ADDENDUM 002

project	Intermountain Alta View Hospital Acute Rehab Unit	project no	19740.00
date	2021-01-18	no. pages	
owner	Intermountain Medical Group Support		
contractor			
bid date	2021-01-26	bid time	4:00 pm

Patient Lift System Layout
Patient Room 1
(Scale 3/8" = 1')

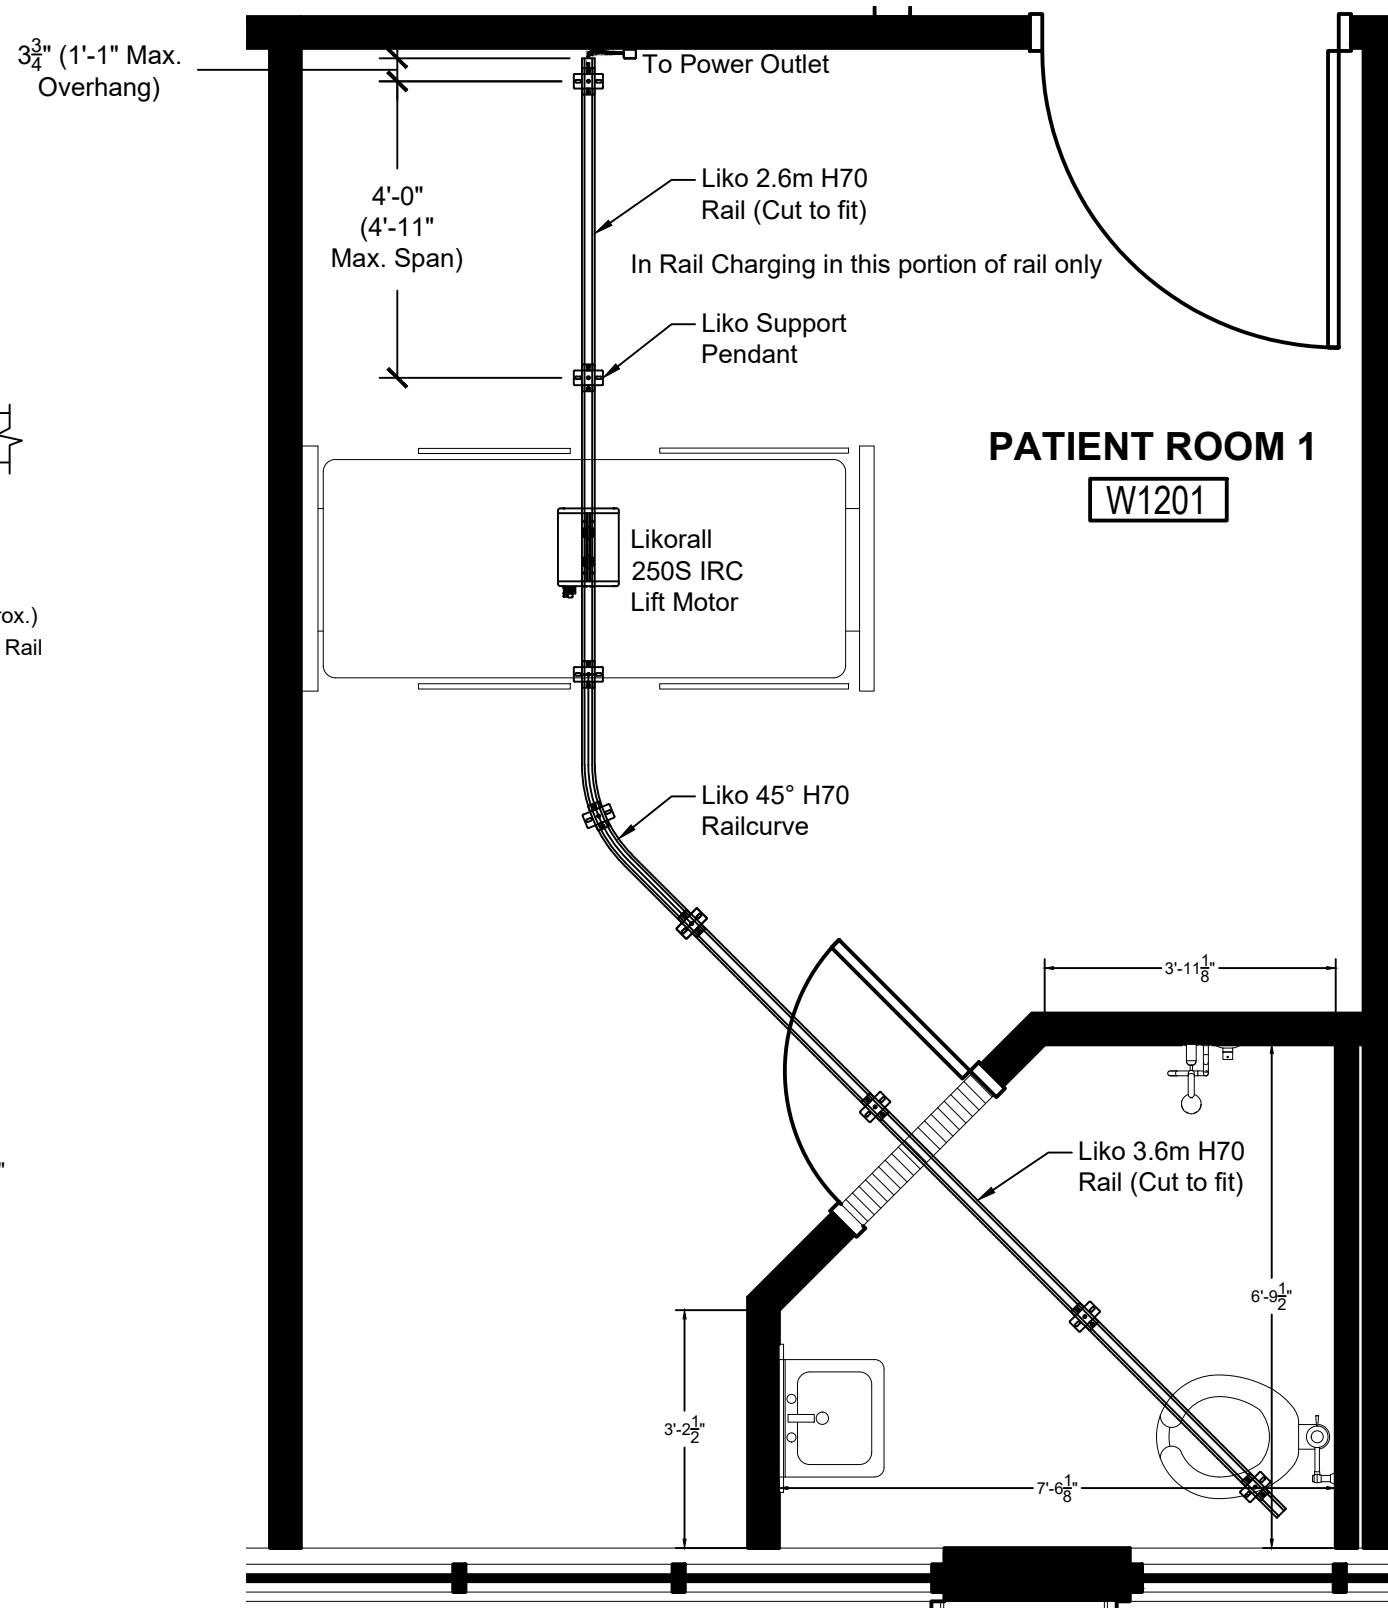
1. Are ceiling mounted patient lifts being considered for the Alta View Hospital Medical Rehab remodel project in Sandy, UT?

RESPONSE: Patient Lifts Vendor's Drawings are included in this Addendum. PROVIDE structural support above the ceiling in Patient rooms 1, 2, 3, 4, & 6, as required in these drawings.
